This study provides insights on the best practices for measuring emissions from orphaned wells and other small, ground-level static point sources using a simple mass flow meter (MFM) based measurement system. The chamber test methods that the authors used are sound and directly applicable to real-world scenarios. The importance of this research is reflected in public and private initiatives to plug orphaned wells, and this work focuses on a resource-efficient method for determining emissions from orphaned wells. As orphan well emissions have been shown to vary over time, these results are especially relevant for firms validating carbon credits and municipalities verifying well plug effectiveness as the MFM method does not require constant supervision and is simple in design. There are some comments to address prior to acceptance, though I believe that the results of this paper are important to disseminate for future orphan well research.

RC2: '[Comment on egusphere-2025-1201](#)', Anonymous Referee #2, 20 Jun 2025

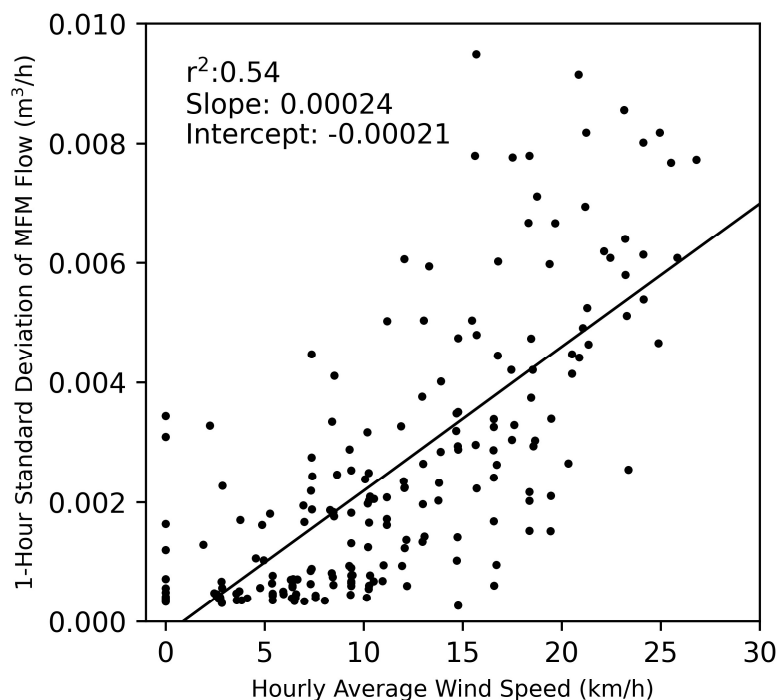
(Line 390) "... considerable variation in the MFC measurements during periods of high wind ..." - Further investigation should be done on variability of MFC measurement versus wind speed. This result is important for the feasibility of MFM measurements in high-wind areas. Suggestions for possible avenues of investigation include 1-hr std. dev. vs wind speed, difference of NOAA wind speed and gusts versus MFC std. dev., refitting Eq. 4 with standardized variables.

KBH: To further evaluate the variability caused by wind, we have re-examined the environmental flow of the MFM with the available NOAA wind data. There was not any distinct gust data reported to enable a separate analysis of gust speeds on the flow measurements. We have added this figure to the SI that illustrates that the hourly standard deviation of the environmental flow tends to increase with wind speed, and added a reference to the figure in the text of the revised manuscript.
